Subject: Drainage Report for Austin Bluffs Parkway (Amendment)
(From Dublin Boulevard to Woodmen Road)

The purpose of this letter is to amend the Drainage Report for Austin Bluffs Parkway from Dublin Boulevard to Woodmen Road. That Drainage Report was prepared by KLH Engineering Consultants, Inc. in July of 1985, and was signed by the City Engineer on December 13, 1985. This amendment includes two major revisions to this report and plan.

AUSTIN BLUFFS PARKWAY - DUBLIN TO WOODMEN
(Revised July 9, 1987)

DRAINAGE PLAN
AUSTIN BLUFFS PARKWAY - DUBLIN TO WOODMEN
 SCALE: 1"=100' DRAWN BY: TMC 83 557 00
 DATE: 06/08/85 CHECKED BY: TMC JOB NO.

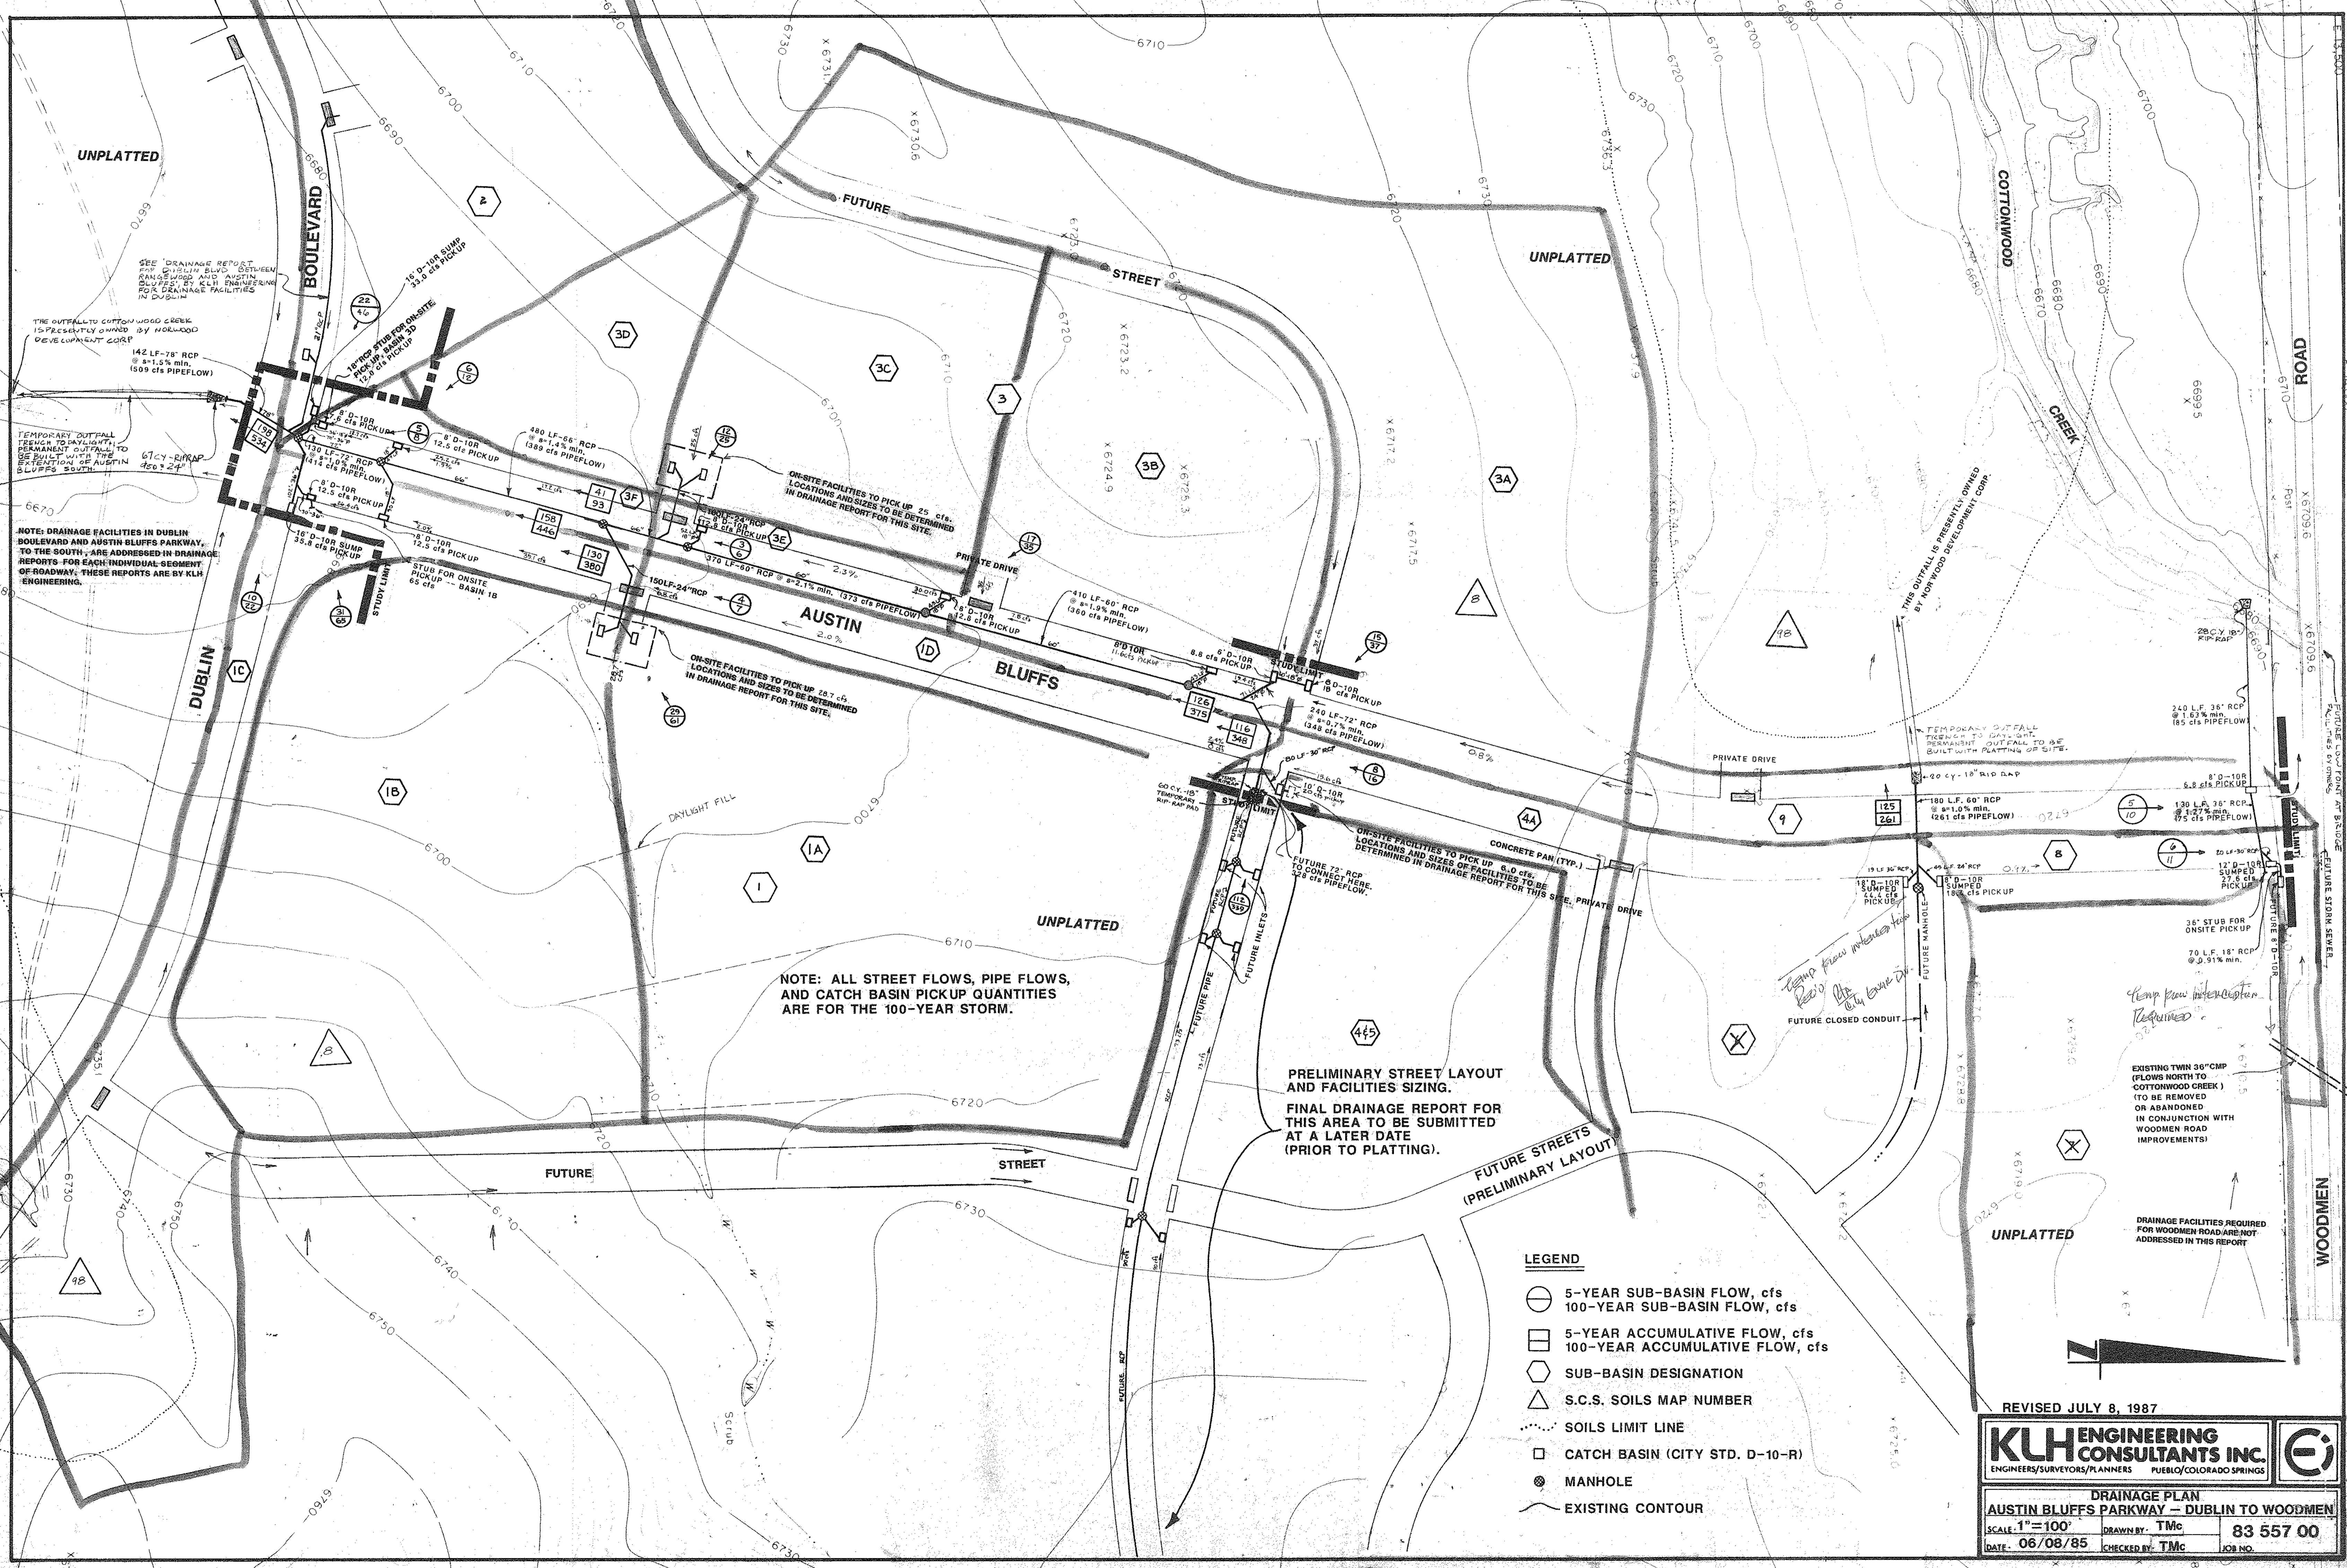
The first revision involves the 100-year pickup in Austin Bluffs Parkway. The Drainage Report originally proposed a 100-year flow pickup in Austin Bluffs Parkway just North of its intersection with Dublin Boulevard. An 18' double-sided sumped inlet and a 20' double-sided sumped inlet were proposed for the West and East sides, respectively, of Austin Bluffs Parkway, with double 42" laterals carrying the flow from these inlets to the storm sewer main in Austin Bluffs. Downstream from this junction, the storm sewer main in Austin Bluffs was designed to carry the 100-year flows.

Upon completion of the street designs for Austin Bluffs and Dublin, it became apparent that a 100-year pickup in this manner was not as practical as in other locations where the design had been successfully implemented. It was determined that creating a sump in Austin Bluffs Parkway would cause less than desirable driving conditions in this case. After several meetings with City Engineering, it was agreed that the most acceptable solution to this problem is to extend the 100-year system North to the proposed auto park minor arterial street, thereby limiting the 100-year street flows in Austin Bluffs Parkway.

The second revision is necessary due to a proposed change in the routing of flows from the sub-basin tributary to the Northeast corner of Woodmen and Powers. Originally, it was assumed that this runoff would be conveyed to the Southwest corner of this intersection and would flow Westerly in a storm sewer system to the box culvert crossing in Austin Bluffs Parkway. However, as a result of a meeting on October 2, 1986, with City Engineering, it was decided that this runoff at the Southwest corner of Woodmen and Powers will

be carried in a closed conduit or an open channel along the South side of Woodmen Road. (Refer to the "Conceptual Master Drainage Plan - Woodmen Road/Austin Bluffs Parkway Intersection and Vicinity," prepared by Leigh Whitehead & Associates, and revised by Obering, Wurth & Associates, November, 1986.) This storm sewer will turn Northward and a culvert will convey the flows across Woodmen Road to Cottonwood Creek. As a result of this proposed change in flow routing, the 5-year and 100-year design flows for the box culvert in Austin Bluffs Parkway have decreased. The revised flows and facilities for this crossing are shown on the attached Drainage Plan.

The accompanying "Drainage Plan for Austin Bluffs Parkway - Dublin to Woodmen" shows the revised storm sewer system proposed for Austin Bluffs Parkway, North of Dublin Boulevard. Flow pickups at inlets and pipeflows in storm sewer mains are shown on this plan. The following is a revised cost estimate for Austin Bluffs Parkway (between Dublin Boulevard and Woodmen Road):

This letter, Drainage Report Statements page, drainage calculations pages, and Revised Drainage Plan shall all become a part of the existing Drainage Report for Austin Bluffs Parkway (from Dublin Boulevard to Woodmen Road) on file with the City, and should be attached to the existing report. The original Drainage Plan in the report pocket should be superseded by the Revised Drainage Plan.
